Ratool Apparels (Extension Sheds)

Ansar Road, Vangnahati, Sreepur Paurosova, Gazipur.
(24.199391N, 90.461407E)
26 September 2021

Observations

Floor load plan not available

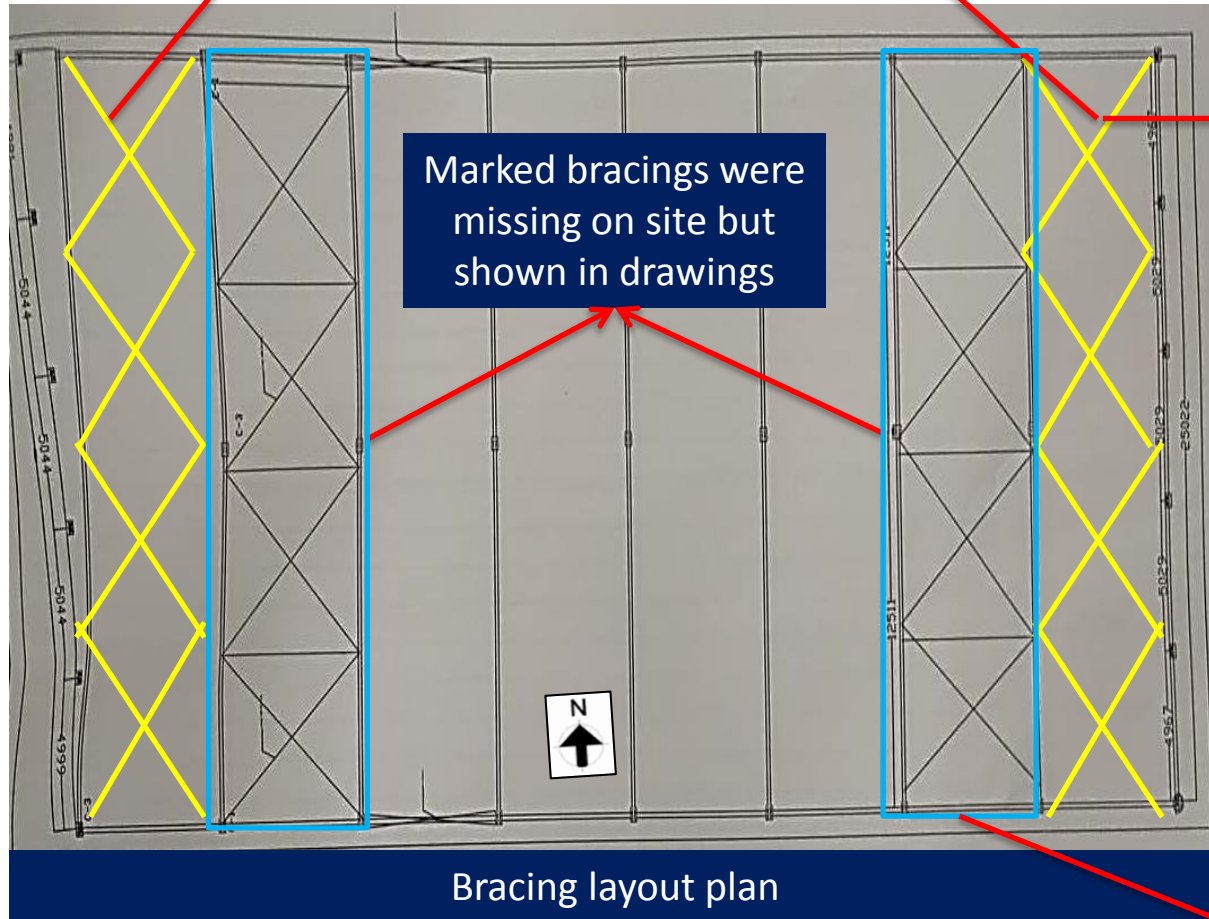
No load plan was prepared. Uncontrolled loading was observed on 2nd floor. As part of design report, building engineer is required to produce a set of floor live load plan. Post the floor load plan and maintain the loading accordingly.

Discrepancy in as-built drawings

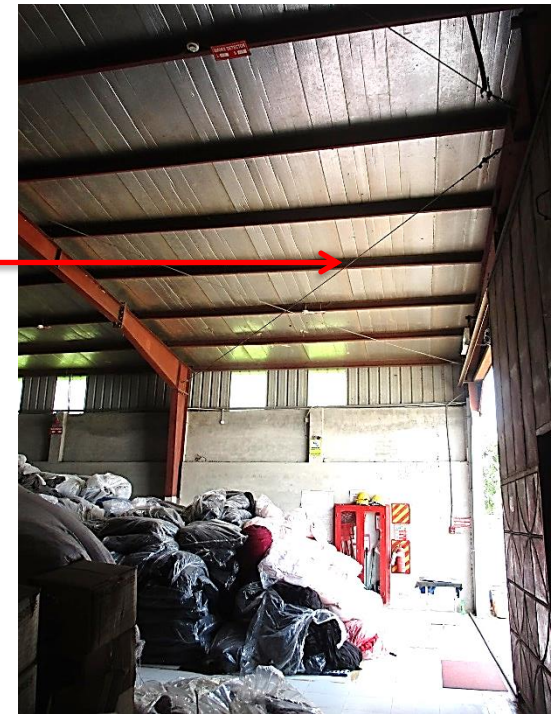
Marked bracings were found on site but not shown in drawings

Marked bracings were missing on site but shown in drawings

Building engineer is required to survey the structure and produce accurate as-built drawings with all structural and architectural details.

Lack of lateral stability

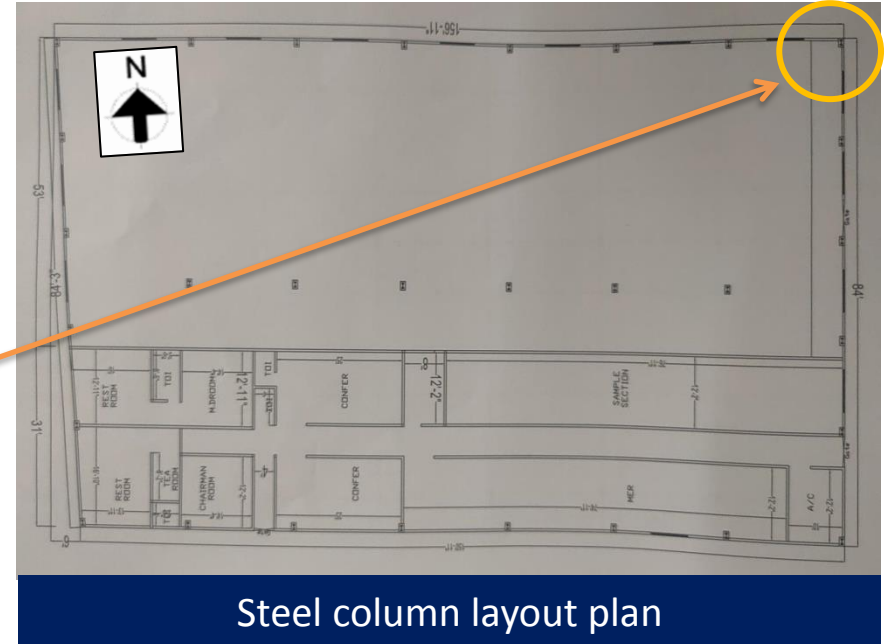
Absence of lateral load transfer media (compression strut) along the eave and ridge

Lack of lateral stability system observed along the eave and ridge. Building engineer is required to check the lateral stability of the structure and suggest proper remedial actions accordingly.

Bracing system has no compression element

Distorted steel column

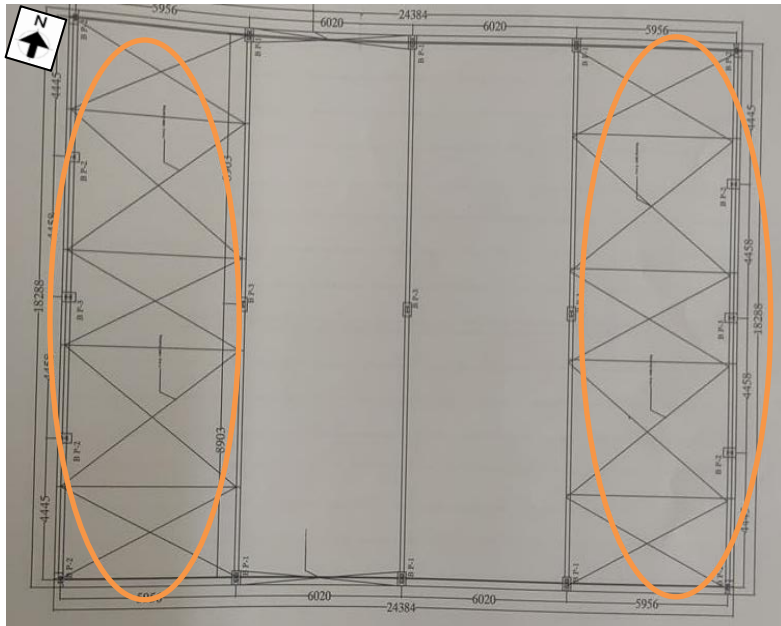
A steel column in the marked location was found distorted. Building engineer is required to repair the distorted column.
